**RE: WEBSTER**  
**RE: DA2024/0487 – PROPERTY 139 LAGOON STREET NARRABEEN**

## Re: Comments on the proposed garage at 139 Lagoon Street, Narrabeen

As instructed, we have reviewed the documents associated with the proposed alterations and additions to the residence at 139 Lagoon Street, Narrabeen. The brief is specific to the impact of the proposed works on the driveway of 141 Lagoon Street, Narrabeen. The purpose of the review is to assist the Town Planner with a response to the proposed development.

MHDP Proposed Garage Floor Plan #2122/A101/A dated 16/1/2024

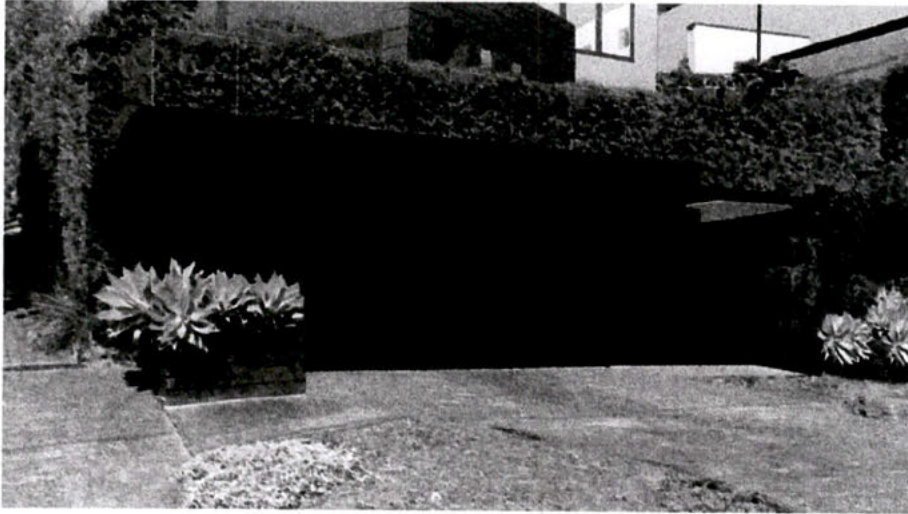
The ground level to the northwestern corner of the site, at the boundary between 139 and 141 Lagoon Street appears to be approximately RL 6.0m. The garage floor level is at RL 5.40. The excavation therefore will be at approximately RL 4.90m to comply with the Geotechnical requirements included in the submission to Council.

The Garage has a nominal offset to the boundary of only 450mm. This important information is only nominated on the ground floor plan #2122/A100/A. This measurement should also be included on the Garage Floor Plan #2122/A101/A.

The contiguous piles indicated on the plans have been suggested to be outside the alignment of the structure for the garage. The contiguous piles should not be installed any closer than 200mm to the boundary to allow for the provision of a boundary fence between the two properties on completion of the works.

The planter (to the northern and western boundary of the development site) and the associated footing extend into the corner of the site with 0.0m offset to both the front and side boundaries. There is an unacceptable level of risk to the driveway of 141 Lagoon Street without the possibility of shoring due to the zero-offset proposed in the plans.

The existing building within the footprint of the excavation and proposed shoring will likely be demolished to carry out the works and reduce site risks during construction.

**MHDP Sediment and Stormwater Plan #2122/SK11/A dated 16/1/2024**

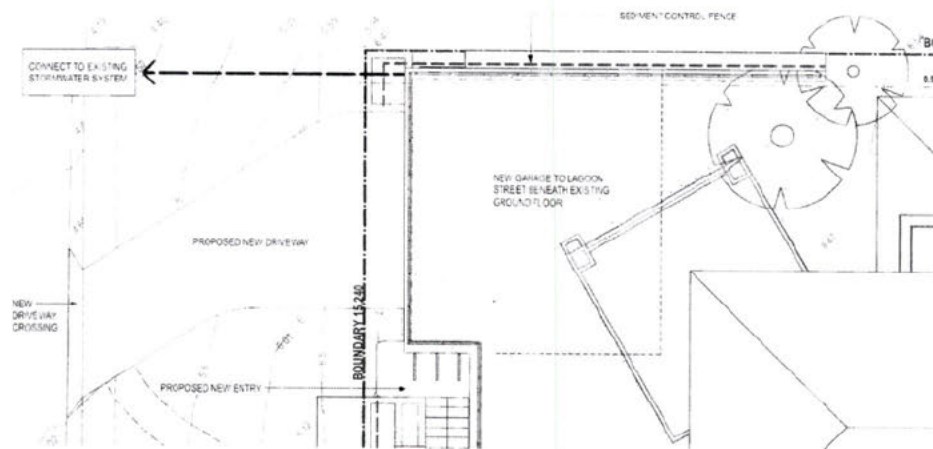
Although the plan has been nominated as the sediment and stormwater management plan, the Council should dismiss this plan and require adequately presented and designed management plans for both the stormwater and the sediment control measures.

We note that the contiguous piles have been nominated along the alignment of the boundary. The design of the early works for the excavation of the garage must be undertaken before the sediment control measures are considered and documented for the works.

The works for the proposed garage and the early works shoring, due to the depth below ground and proximity to the boundary, will require a redesign and adequate network for the stormwater system. The location nominated for the existing stormwater pipework will require investigation and a plan of management. Please refer to the extract below from Northern Beaches Council DA and modification lodgement requirements nominating the information required for stormwater plans.

MHDP #2122/A101/A Proposed Garage Floor Plan dated 16/1/2024

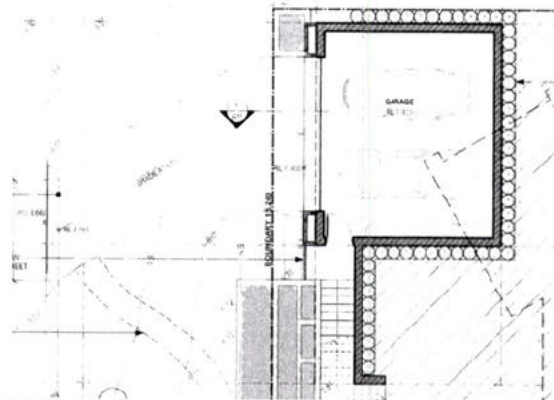
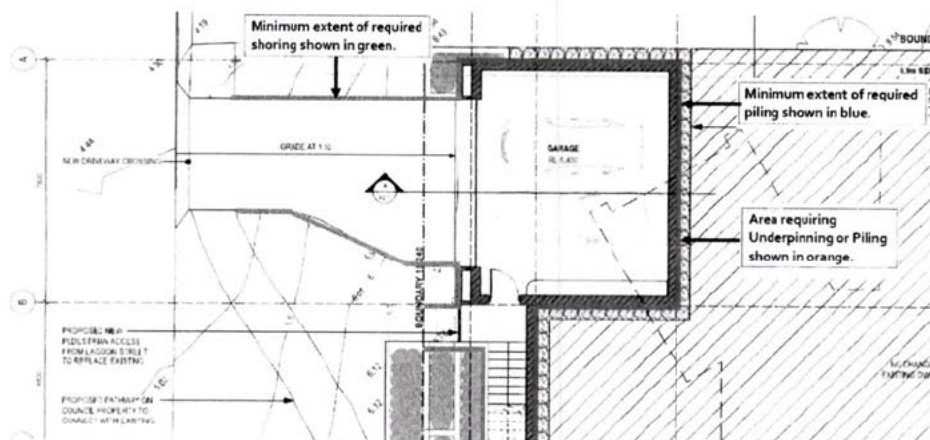
The proposed ground floor plan in the Architectural set has the same drawing number, revision and date as the drawing used in the Geotechnical Engineers reporting however the extent of the planter boxes and the driveway alignment are different.

The Council should insist that the Application be resubmitted with the corrected Architectural set and inclusions in the Geotechnical Engineering reporting. There should not be two different versions of the same drawing in the Application to Council.

The plans and details must also include the relative levels of the northern neighbour's driveway due to the critical involvement of the parameter for the shoring design along that boundary. We note that even with a compliant side boundary setback, shoring will be required for the excavation as defined by the Geotechnical Engineer.

MHDP Landscape Area Calculation #2122/A005/A dated 16/1/2024

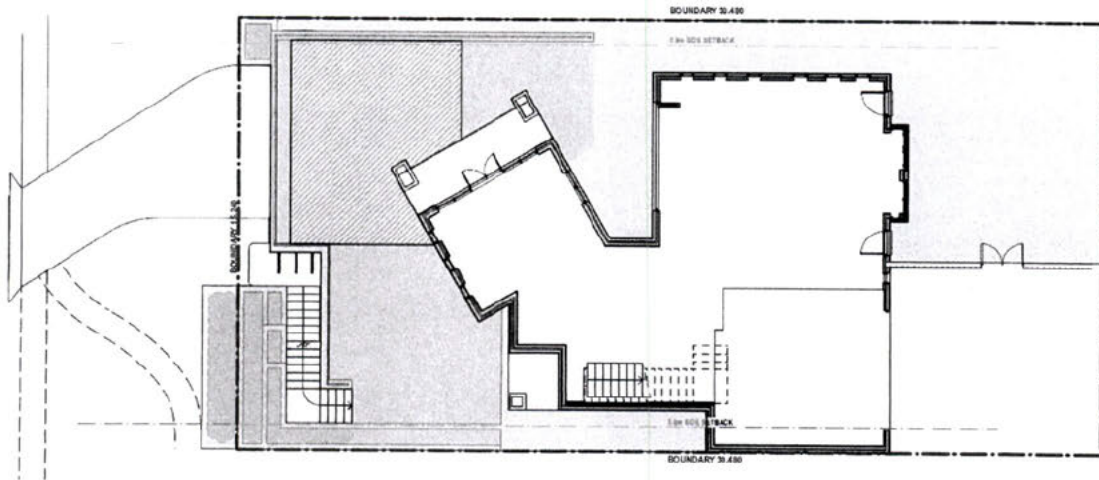
Areas for the landscape open space should be reviewed given that the calculation for the landscape open space by the Architect includes the areas where the contiguous piles will be installed, blockwork retaining walls and the area over the suspended slabs.

Section D1 landscape open space. Any open space areas with a dimension of less than 2m are excluded from the calculation. The landscape open space must be at ground level. Soil depth must be greater than 1000mm.

This therefore excludes the following areas nominated by the Architect in the calculation:

- areas between the garage and the northern boundary,
- the entire area over the suspended slab of the proposed garage,
- the blockwork along the sides of the stairs,
- the planters to the western side of the entry stairs and the western boundary,
- the raised planter along the length of the southern boundary
- the grassed area between the southern boundary and the existing residence.

To be able to count the area along the northern side of the garage as landscape open space, the garage will need to be relocated with an offset to the common boundary of 139 and 141 Lagoon Street in excess of 2000mm. This modification will also significantly reduce the risks to the driveway and persons at 141 Lagoon Street.

WGG Reporting #J5243 dated 18<sup>th</sup> January 2024

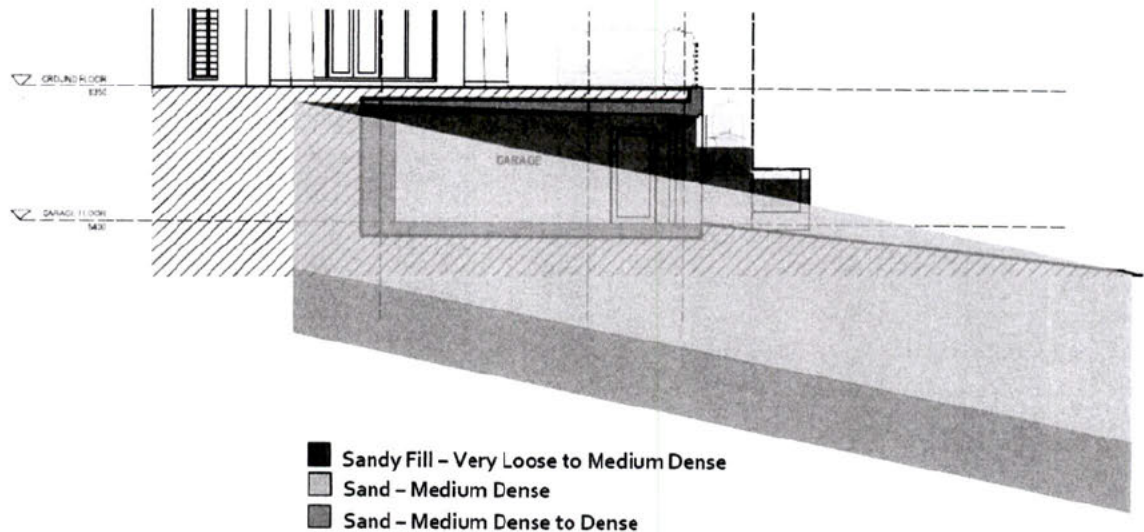
The White Geotechnical Group indicates the following within the reporting. Without the levels of the neighbouring driveway along the length of the northern boundary of the development site, the estimation of the depth for the excavation is not an accurate quantity.

The description of the works should also address that the garage is located along the northern boundary of the development site.

There should have been an insistence/requirement by the Geotechnical Engineer and the Architect that the finished levels of the driveway to 141 Lagoon Street, Narrabeen be included in the Survey used for the proposal.

Sectional details for the proposed works should have been included to define the extent of the involvement and works required to ensure the stability of the neighbouring site. The detailing would assist in the planning for the shoring, inclusion of services (if possible) and the understanding that plants will not grow over the shoring system (nominated contiguous piles for example).
